OFFICE OF RIVER PROTECTION

SUBMITTAL OF HANFORD FACILITY RESOURCE CONSERVATION AND RECOVERY ACT PERMIT MODIFICATION NOTIFICATION FORM 24590-LAW-PCN-ENV-17-012

**Hanford Facility RCRA Permit Modification Notification
Form 24590-LAW-PCN-ENV-17-012**

Hanford Facility RCRA Permit Modification Notification Form
Part III, Operating Unit 10
Waste Treatment and Immobilization Plant

24590-LAW-M6-LOP-00004002

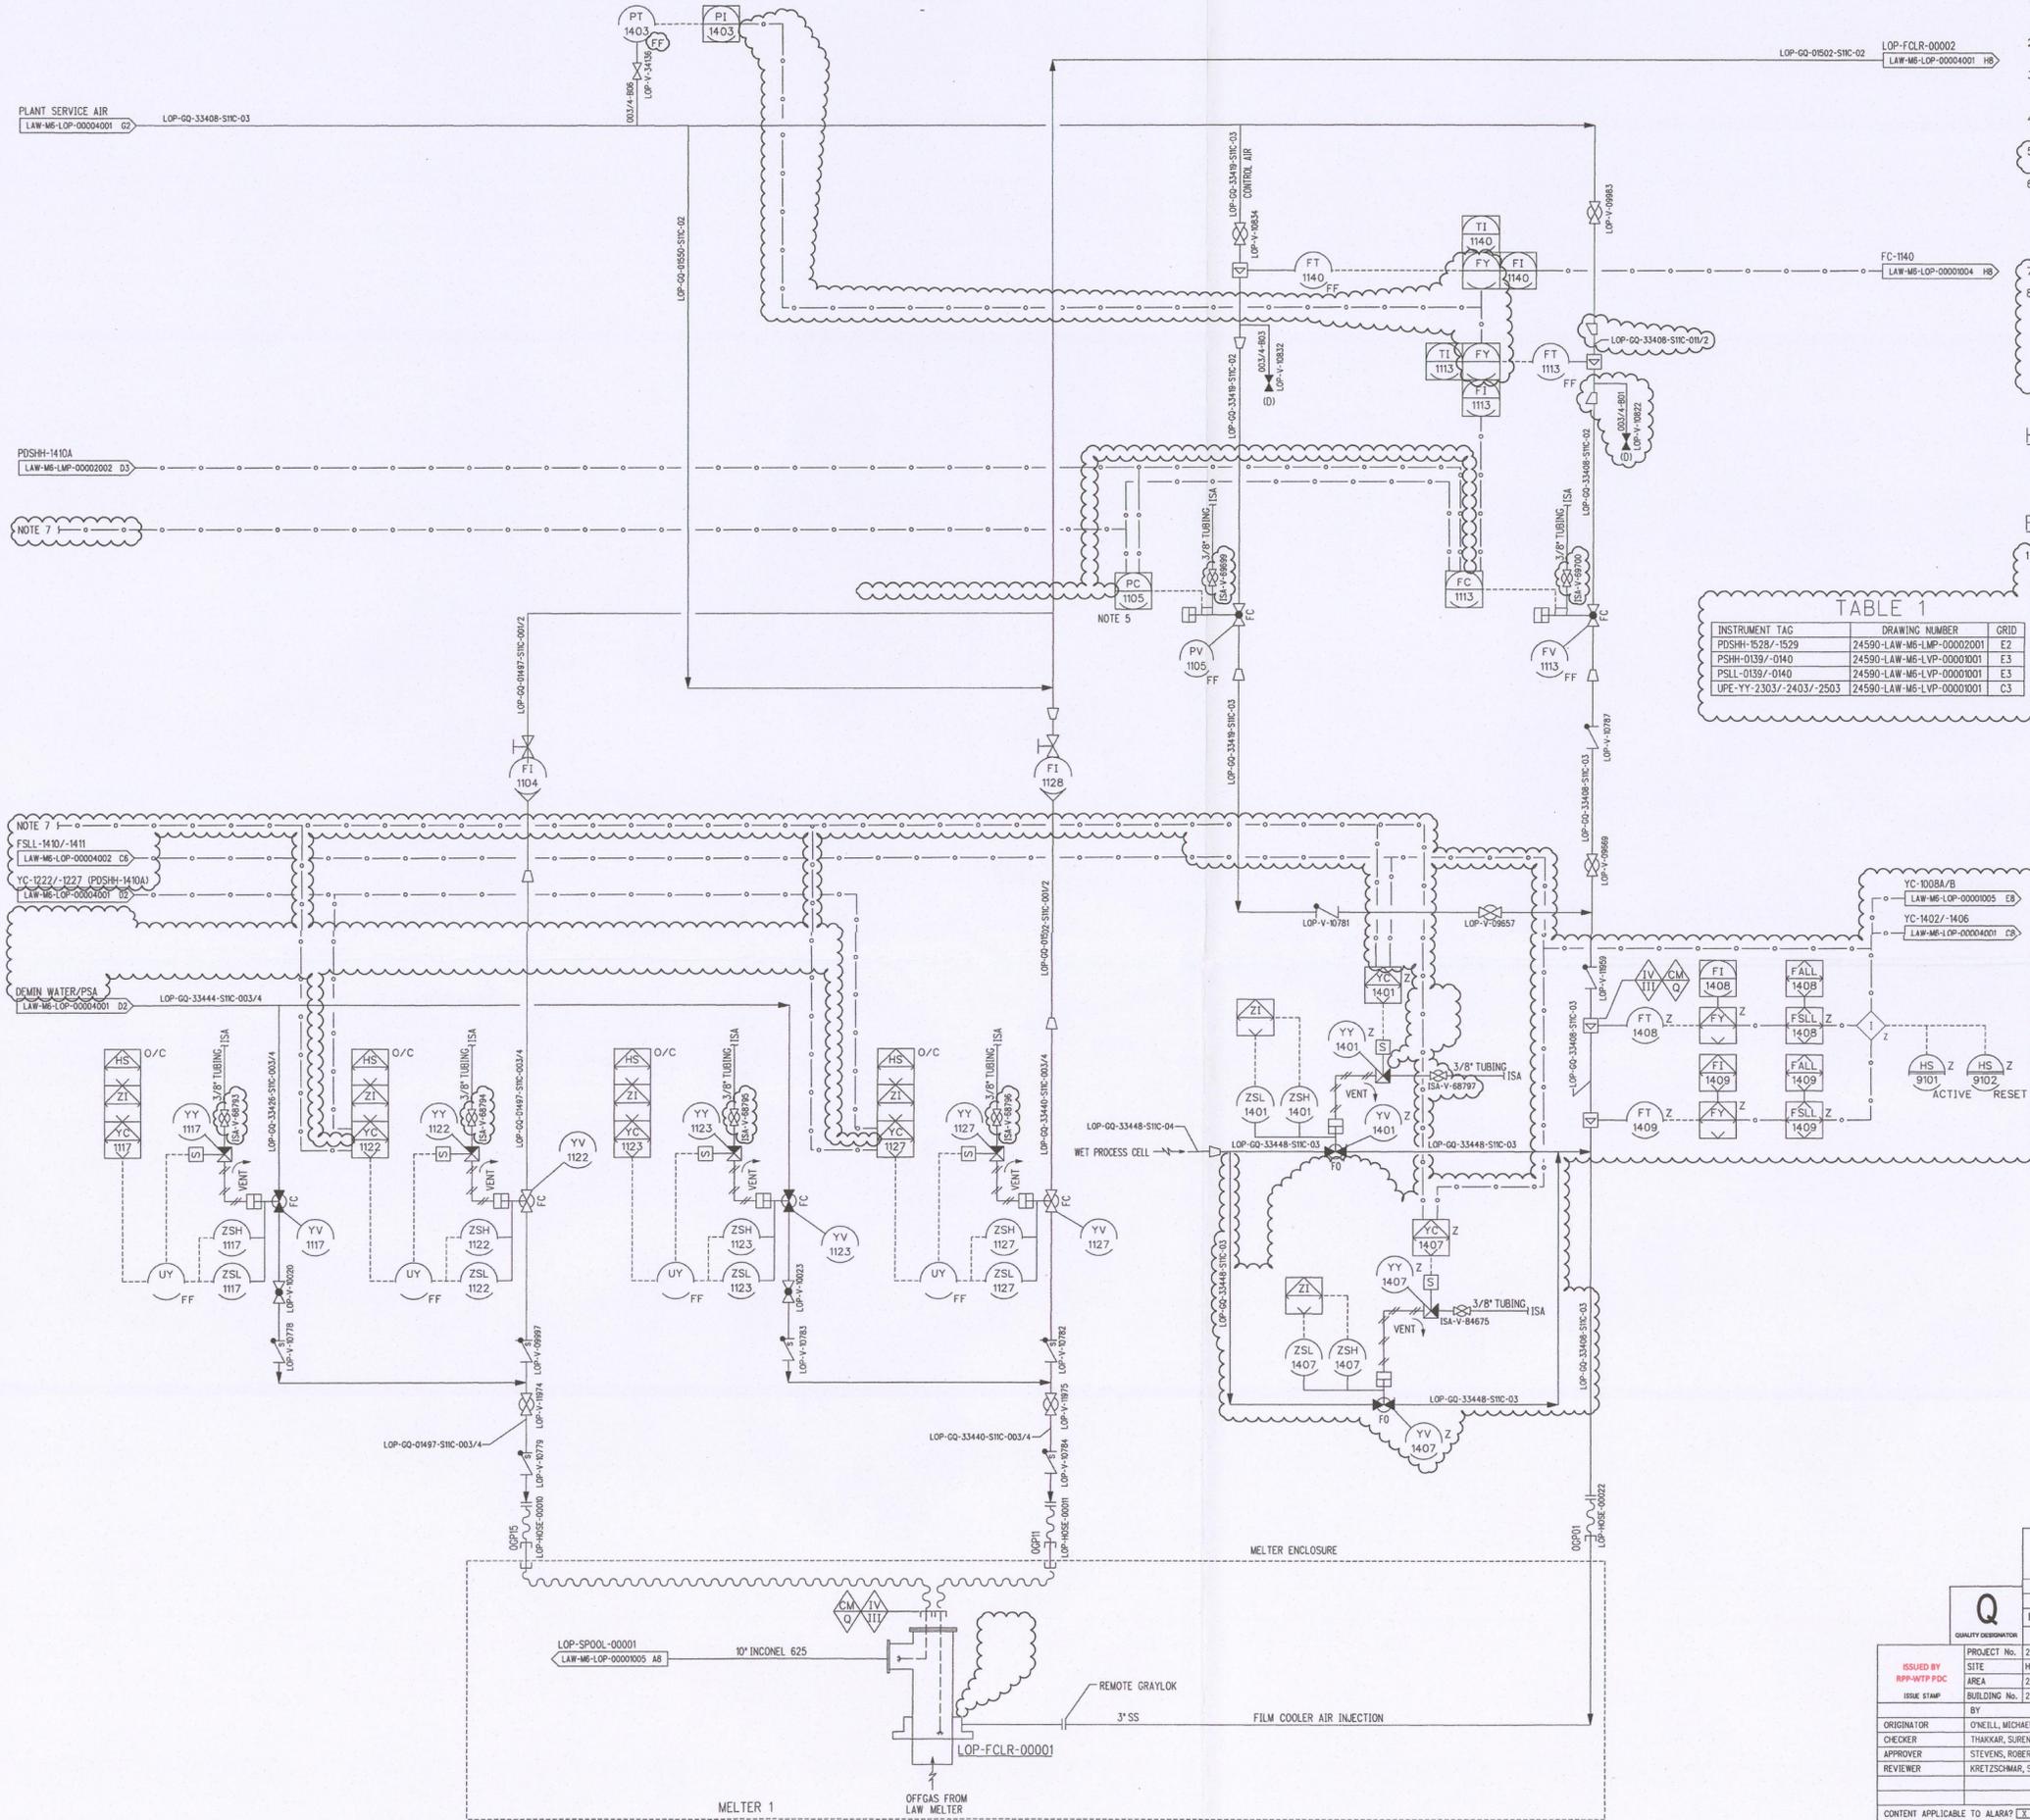
Changes to the P&ID (24590-LAW-M6-LOP-00004002, Rev. 1) for the Melter 1 Primary Offgas Film Cooler (LOP-FCLR-00001) are summarized below:

- Added or modified notes in the Notes section. Revised the References section.
- Added new Table 1 (Grid F2).
- Changed valve symbol from gate valve to ball valve for ISA-V-69699, ISA-V-69700 and ISA-V-68793 through ISA-V-68797 (Grids D4 to D8, F3 and F5).

- Revised instrumentation control strategy by the addition of instrumentation, lines, and valves (multiple grids).
- Added 1½" reducers upstream and downstream of flow rate transmitter FT-1113 and new piping LOP-GQ-33408-S11C-011/2. Replaced LOP-GQ-33408-S11C-003/4-B05 with LOP-GQ-33408-S11C-003/4-B01 (Grids F3 and G3).

- Deleted seismic and quality flags near film cooler LOP-FCLR-00001 and LOP valve ISA-V-68797 (Grids A5 and D4).
- Added valve YV-1407 and associated instrumentation and lines (Grids B3 to B4, C2 to C4, D2 to D4 and E4 to E8).

- Added label for piping LOP-GQ-33408-S11C-03 (Grid C3).
- Added, revised or deleted off-sheet connectors (multiple grids).
- Incorporated changes from change documentation identified in the Notes section.

LOP-FCLR-00003
MELTER 2 PRIMARY
OFFGAS FILM COOLER
23W x 38'L x 4'TH

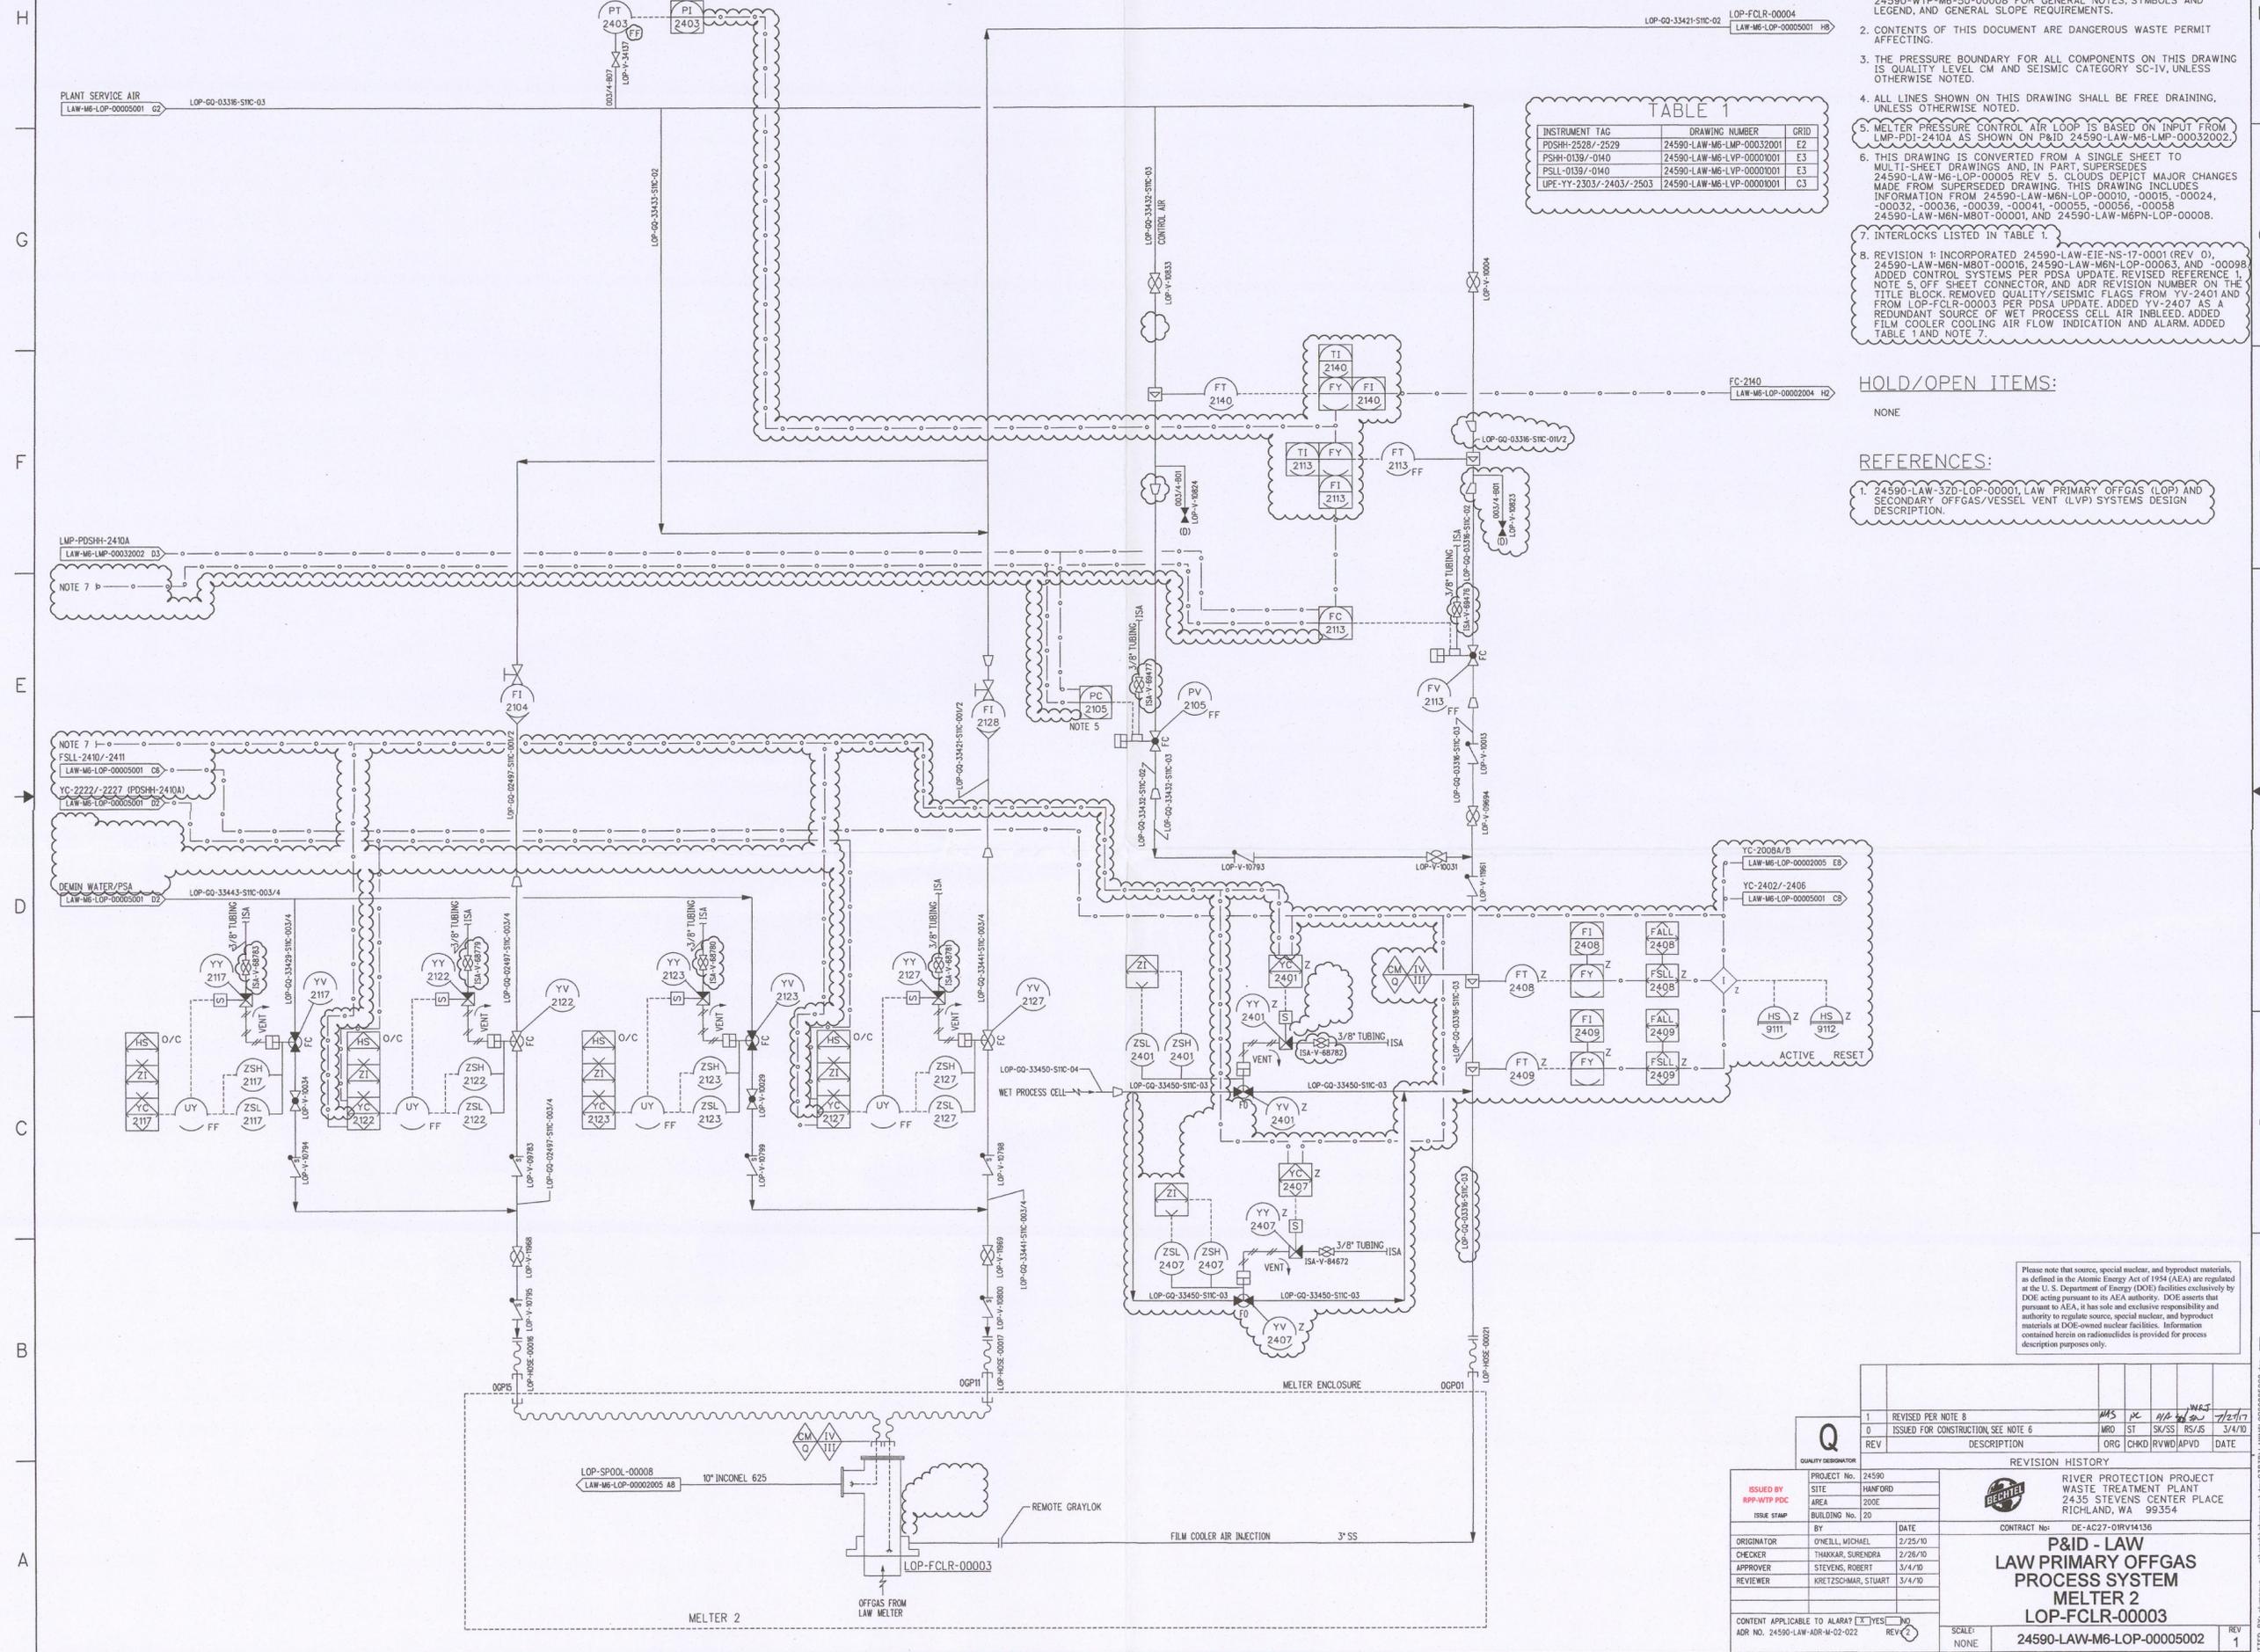
Changes to the P&ID (24590-LAW-M6-LOP-00005002, Rev. 1) for the Melter 2 Primary Offgas Film Cooler (LOP-FCLR-00003) are summarized below:

- Added or modified notes in the Notes section. Revised the References section.
- Added new Table 1 (Grid G3).
- Changed valve symbol from gate valve to ball valve for ISA-V-69476, ISA-V-69477 and ISA-V-68779 through ISA-V-68783 (Grids C4, D5 to D8 and E3 to E4).

- Revised instrumentation control strategy by the addition of instrumentation, lines, and valves (multiple grids).
- Added 1½" reducers upstream and downstream of flow rate transmitter FT-2113 and new piping LOP-GQ-03316-S11C-011/2. Replaced LOP-GQ-03316-S11C-003/4-B04 with LOP-GQ-03316-S11C-003/4-B01 (Grid F3).

- Deleted seismic and quality flags near film cooler LOP-FCLR-00003 and LOP valve ISA-V-68782 (Grids A5 and C4).
- Added valve YV-2407 and associated instrumentation and lines (Grids B4, C2 to C4, D2 to D4 and E5 to E8).

- Added label for piping LOP-GQ-03316-S11C-03 (Grid C3).
- Relocated reducer further downstream of LOP-V-10833 and flow rate transmitter FT-2140 (Grids F4 and G4).

- Added, revised or deleted off-sheet connectors (multiple grids).
- Incorporated changes from change documentation identified in the Notes section.
